RESOLUTION NO. 2025-067

A RESOLUTION OF THE BOARD OF COUNTY COMMISSIONERS OF COLLIER COUNTY, FLORIDA, AS THE GOVERNING BODY OF COLLIER COUNTY, FLORIDA AND EX-OFFICIO GOVERNING BOARD OF THE COLLIER COUNTY WATER-SEWER DISTRICT, APPROVING AMENDMENTS TO THE COLLIER COUNTY WATER-SEWER DISTRICT'S UTILITIES STANDARDS MANUAL, WHICH IS AN INTEGRAL PART OF COLLIER COUNTY ORDINANCE NO. 2004-31, AS AMENDED, KNOWN AS THE COLLIER COUNTY UTILITIES STANDARDS AND PROCEDURES ORDINANCE, WHICH IS CODIFIED IN CHAPTER 134, ARTICLE III OF THE CODE OF LAWS AND ORDINANCES; AND PROVIDING FOR AN EFFECTIVE DATE.

The amendment of the Collier County Water-Sewer District Utilities Standards Manual as provided in attached Exhibit "A" is hereby approved and shall immediately take effect.

INTRODUCTION

PERMANENT BACTERIAL SAMPLE POINT DETAIL

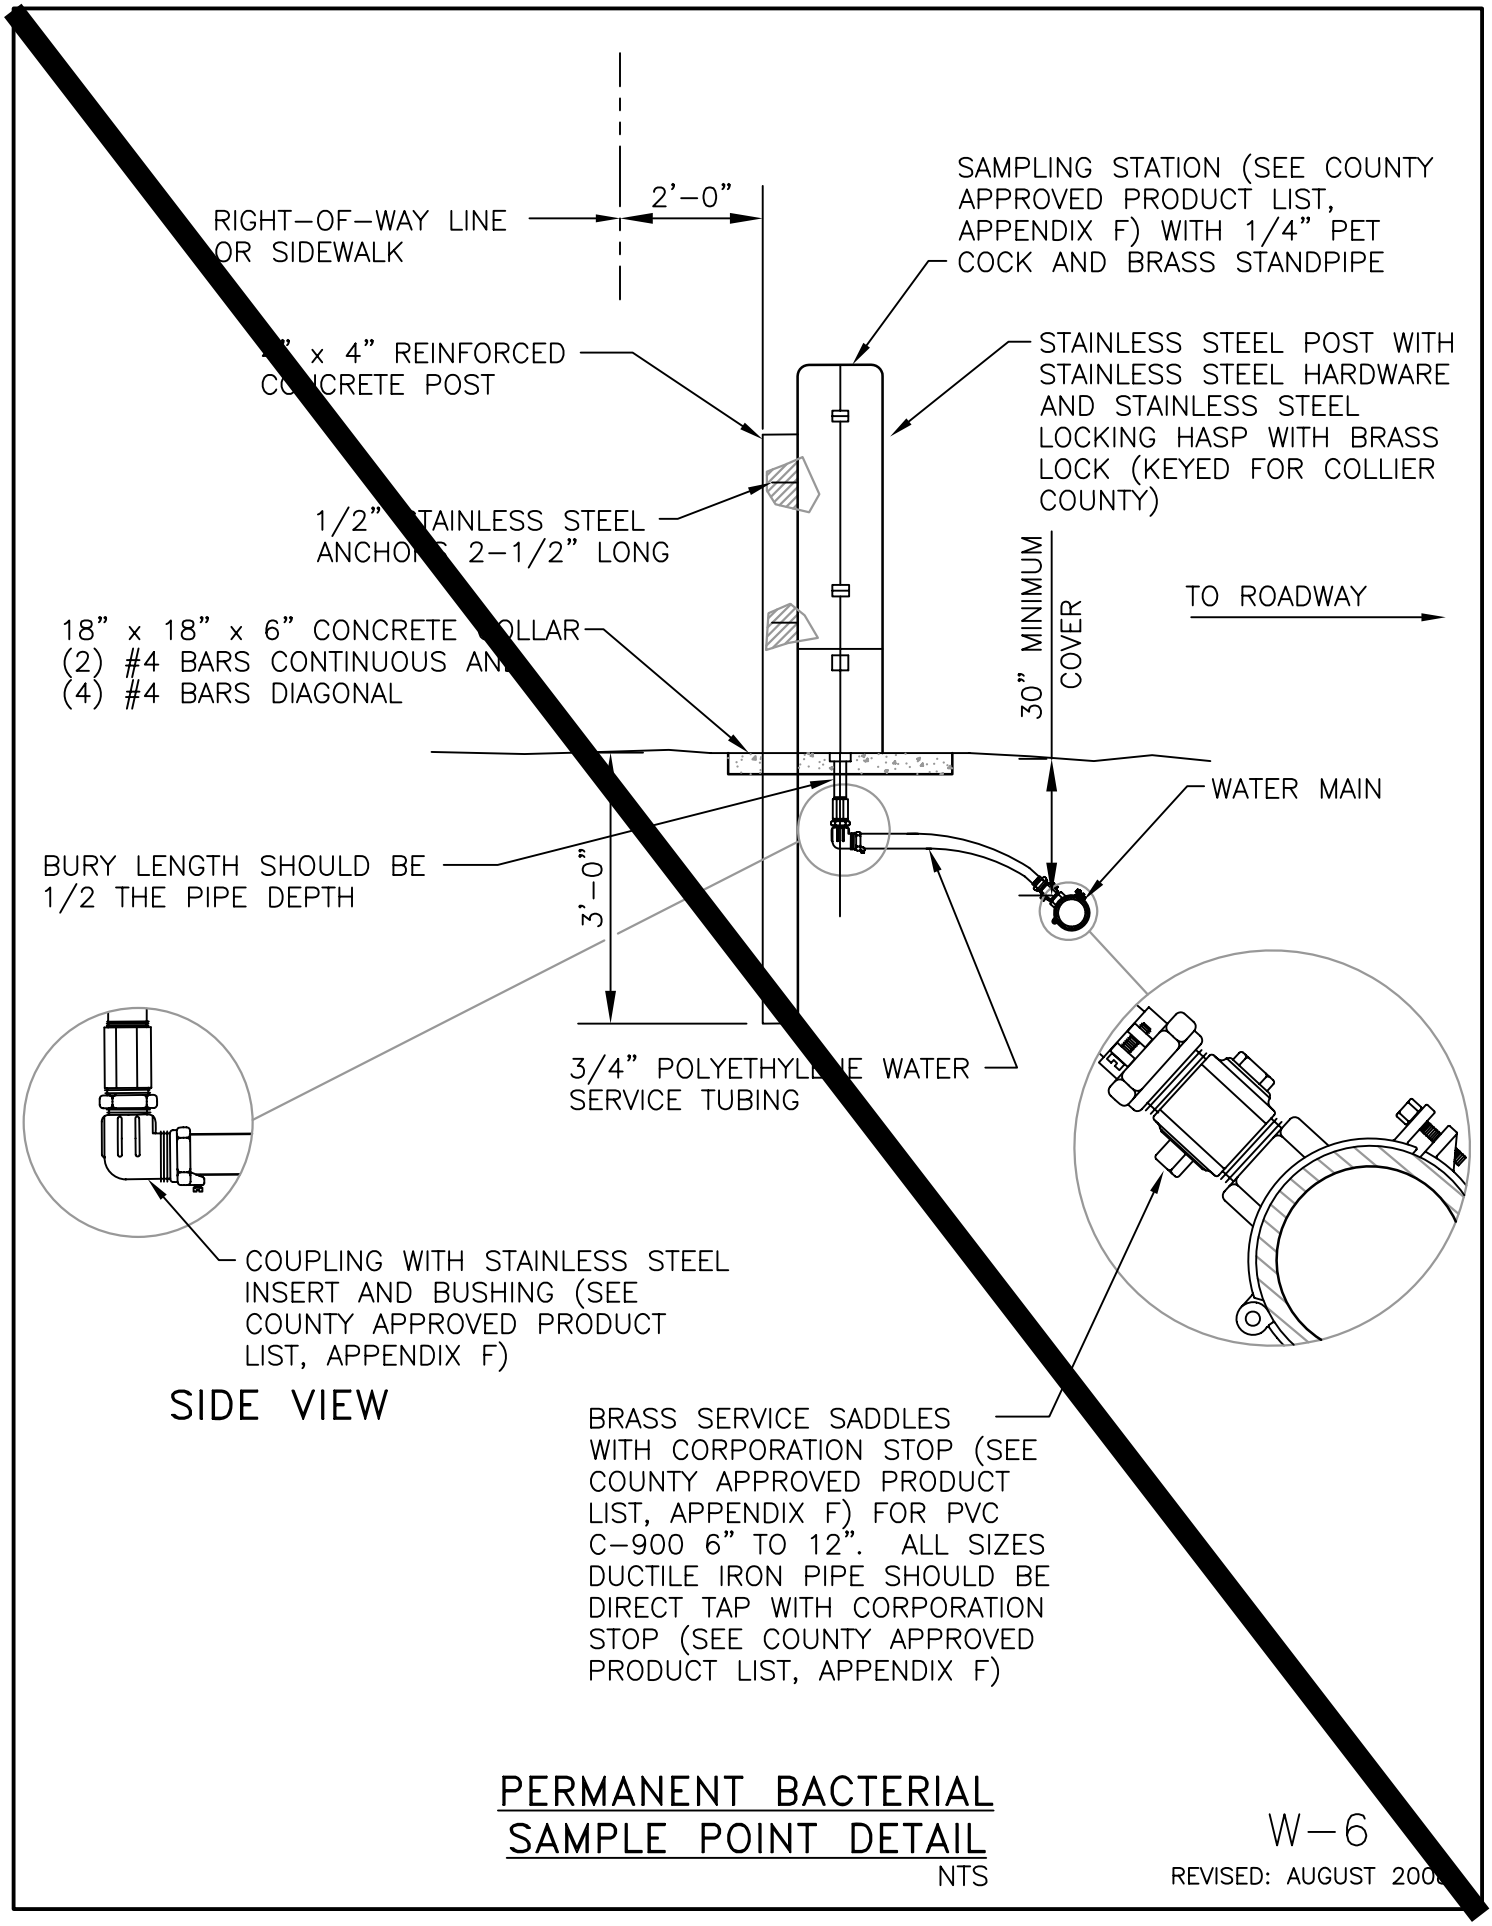
32	W-6	Permanent Bacterial Sample Point Detail	Brass models added to approved product list. Stainless steel models removed.	Potential cost savings
33	W-12	Typical short and long side water service meter setting detail for connection to water main	Temporary construction fence graphic added around the water meter boxes, with note referencing 'Note 8' on Detail W-12A. Revised meter callout to 'AMI/AMR meter'.	$200/installation
34	W-12A	Service connection sizing chart and notes	Added note # 8 to Equipment Specifications, calling out temporary construction fence installation.	$200/installation
35	W-13	3" and over potable water meter assembly detail	Added note # 9 to Equipment Specifications including maintenance access in County CUE or R/W.	None

PUMP STATION DETAIL - PLAN

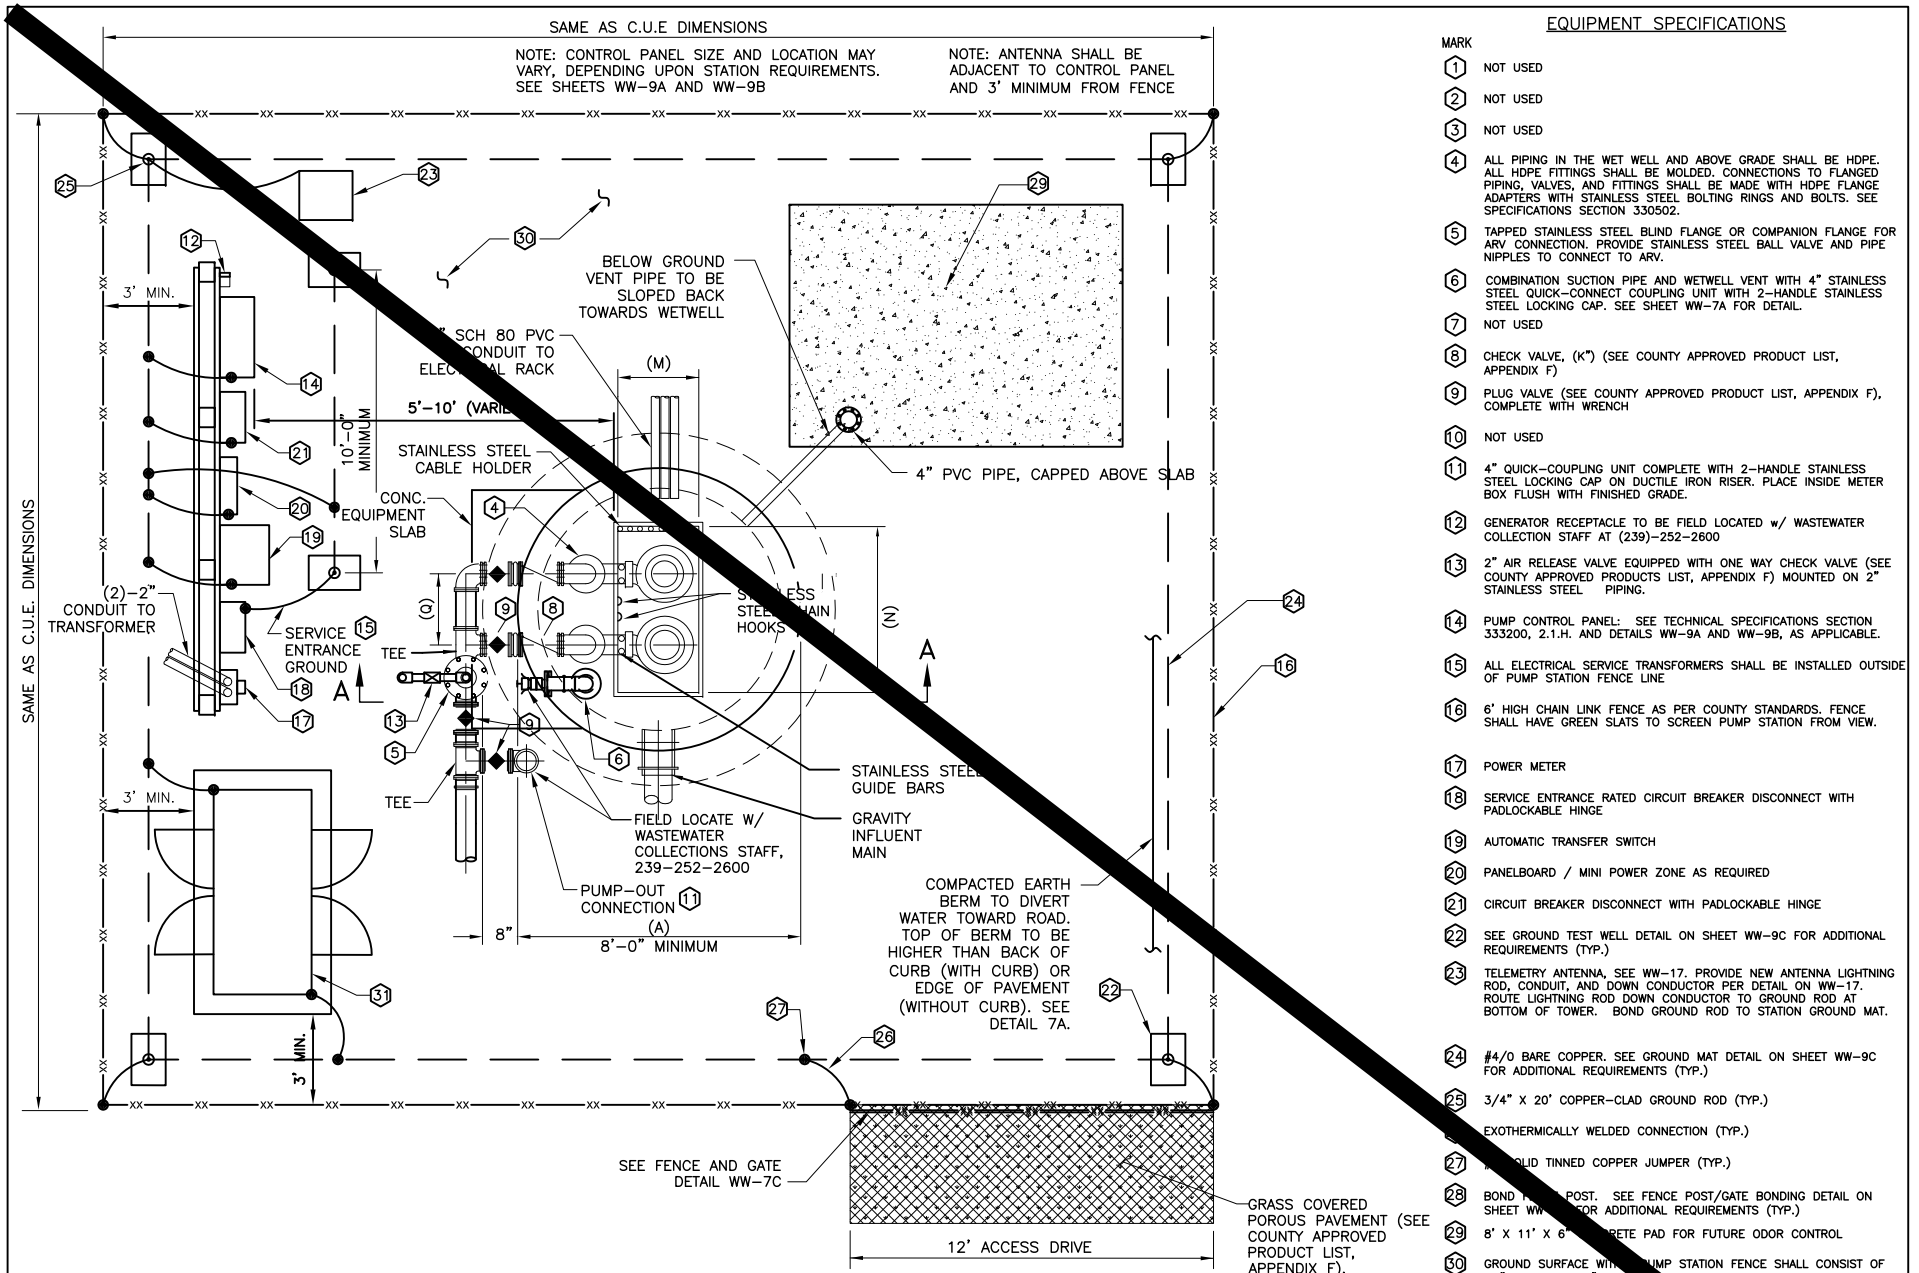
54	WW-8	Pump Station Detail - Plan	Callout for access drive material was modified by deleting the option for grass covered porous pavement and leaving only the option for concrete or asphalt. Access drive dimension was set as the distance between the fence and the wetwell top. Callout ‘Provide clear distance between fence and wetwell top’ was added.	Potential cost savings
55	WW-8	Pump Station Detail - Plan	Note added next to section A-A, referencing plan view on detail WW-7.	None
56	WW-8	Pump Station Detail - Plan	Note added next to Dimension Table, ‘(To be completed by EOR)’.	None

COMMUNITY PUMP STATION WITH GENERATOR DETAIL - PLAN

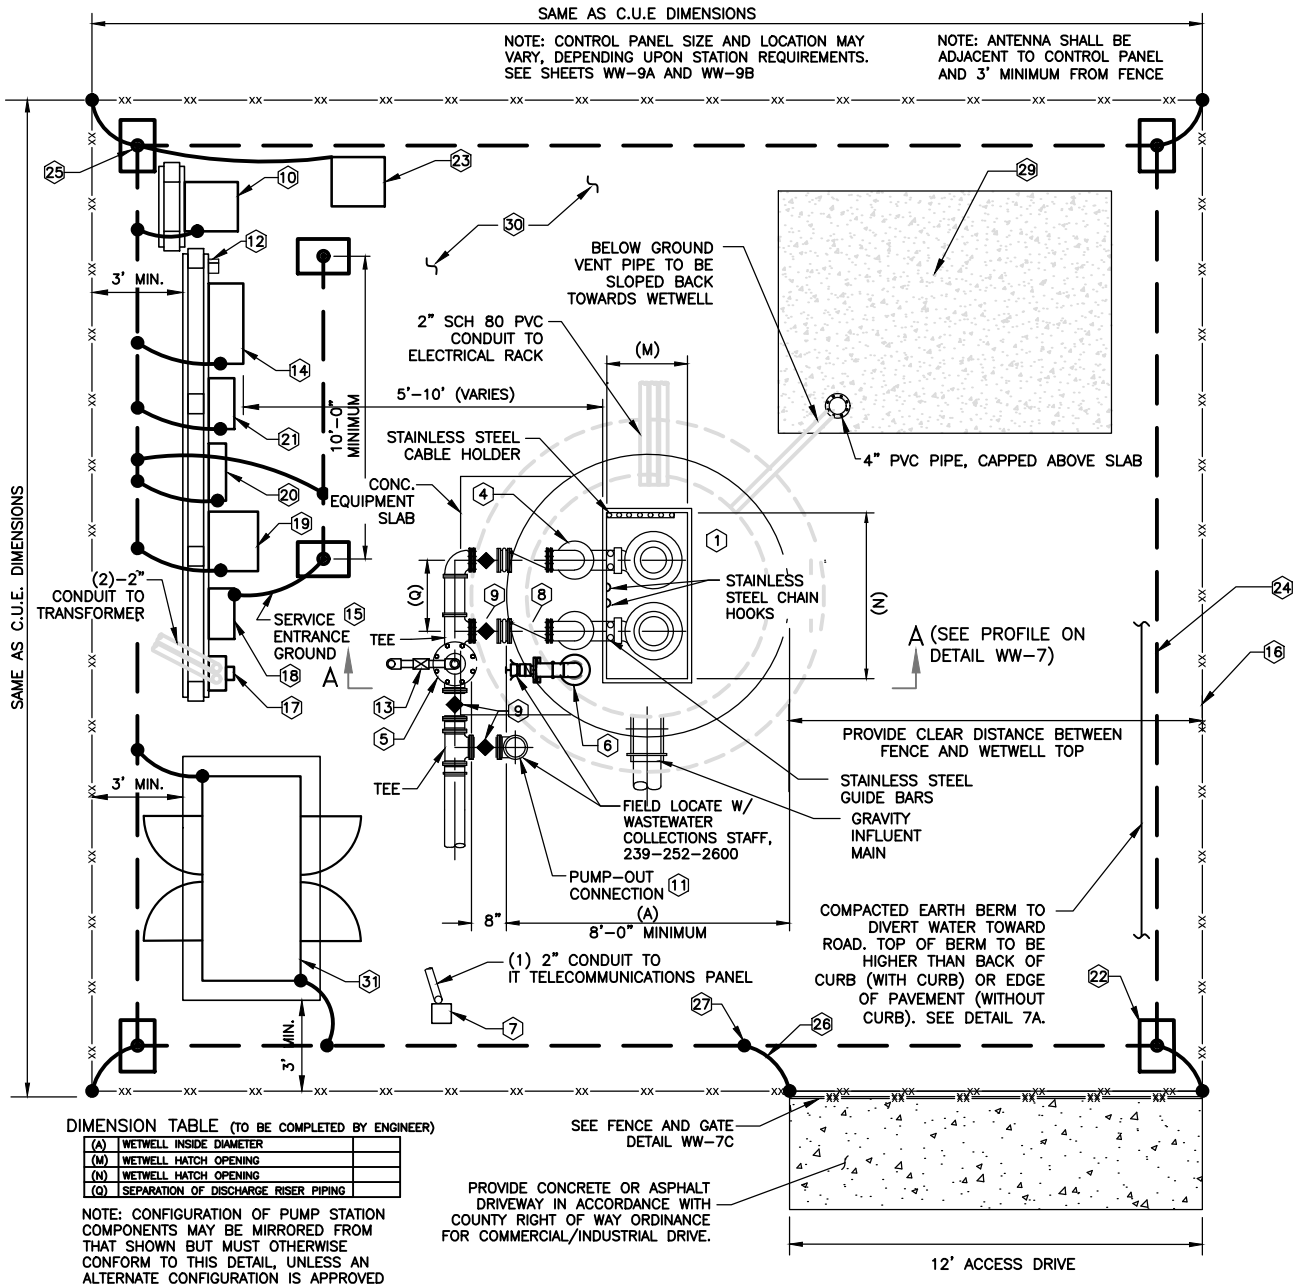
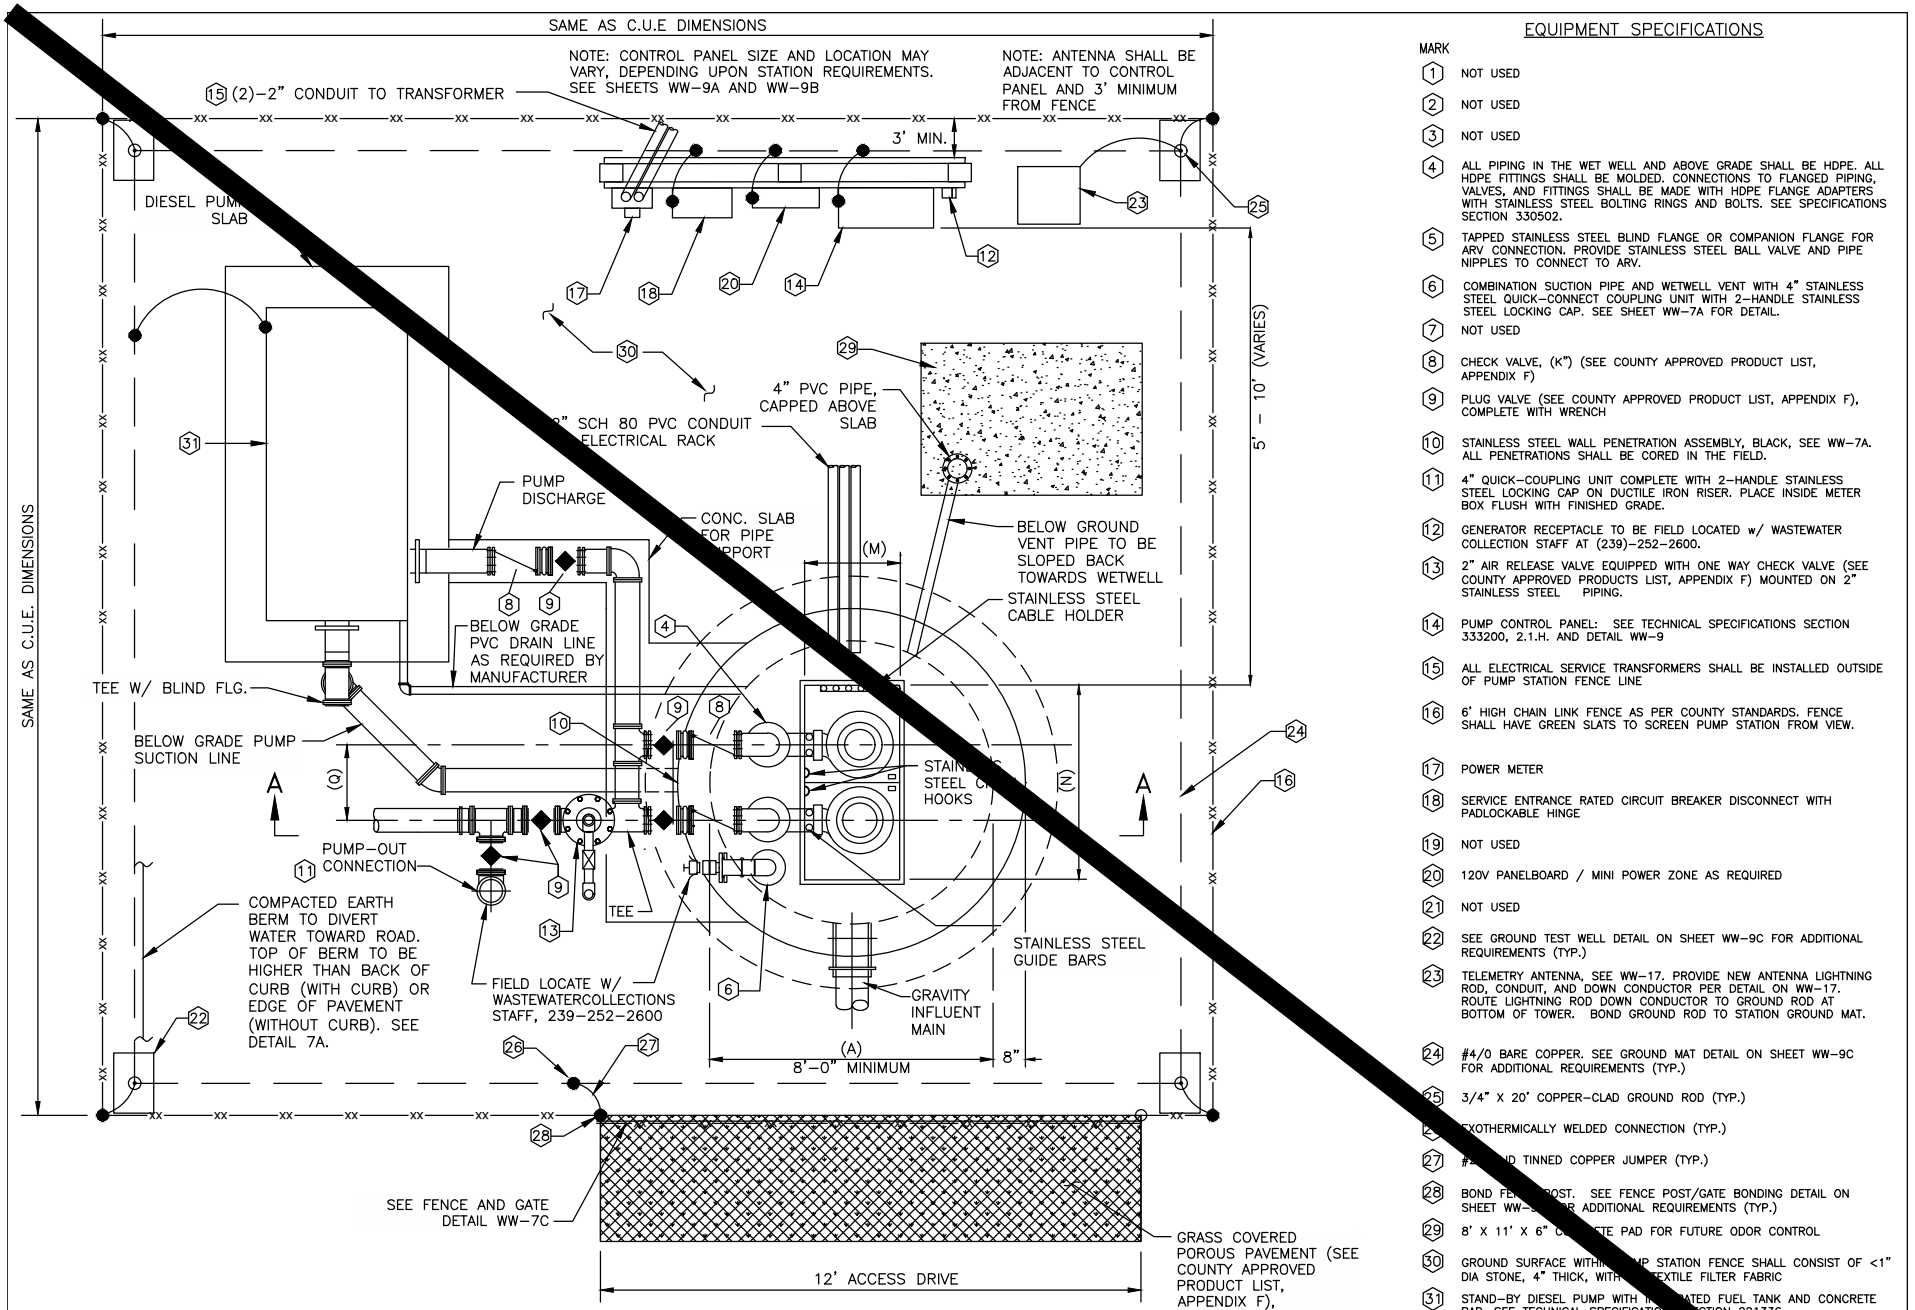
Item	Sub-Section I Detail		Revision Summary	Fiscal Impact of change to Developer (Approx.)
57	WW-8A	Community Pump Station with Generator Detail - Plan	Mark # 4 was modified by adding the sentence 'No spacers permitted between check and plug valves'.	None
58	WW-8A	Community Pump Station with Generator Detail - Plan	Mark # 7 was added: "Fiber-optic handhole: See technical details specification 409500 and detail G-12, where applicable". Conduit and handhole graphic added to the detail.	$15,000 approx. cost to install equipment for a fiber connected site. Additional cost will be required to install fiber to the pump station from the County's network.
59	WW-8A	Community Pump Station with Generator Detail - Plan	Mark # 8 was modified by adding the text "with external weight/lever".	None
60	WW-8A	Community Pump Station with Generator Detail - Plan	Mark # 10 was added: "IT telecommunications panel: See technical specification 409500 and detail G-12, where applicable". IT telecommunications graphic added to the detail.	$15,000 approx. cost to install equipment for a fiber connected site. Additional cost will be required to install fiber to the pump station from the County's network.

Item	Sub-Section I Detail		Revision Summary	Fiscal Impact of change to Developer (Approx.)
64	WW-8A	Community Pump Station with Generator Detail - Plan	Note added next to Dimension Table, '(To be completed by EOR)'.	None
65	WW-8B	Community Pump Station with Diesel Pump Detail - Plan	Mark # 2 was added: "Fiber-optic handhole: See technical details specification 409500 and detail G-12, where applicable". Conduit and handhole graphic added to the detail.	$15,000 approx. cost to install equipment for a fiber connected site. Additional cost will be required to install fiber to the pump station from the County's network.
66	WW-8B	Community Pump Station with Diesel Pump Detail - Plan	Mark # 4 was modified by adding the sentence "No spacers permitted between check and plug valves".	None
67	WW-8B	Community Pump Station with Diesel Pump Detail - Plan	Mark # 7 was added: "Fiber-optic handhole: See technical details specification 409500 and detail G-12, where applicable". Conduit and handhole graphic added to the detail.	$15,000 approx. cost to install equipment for a fiber connected site. Additional cost will be required to install fiber to the pump station from the County's network.
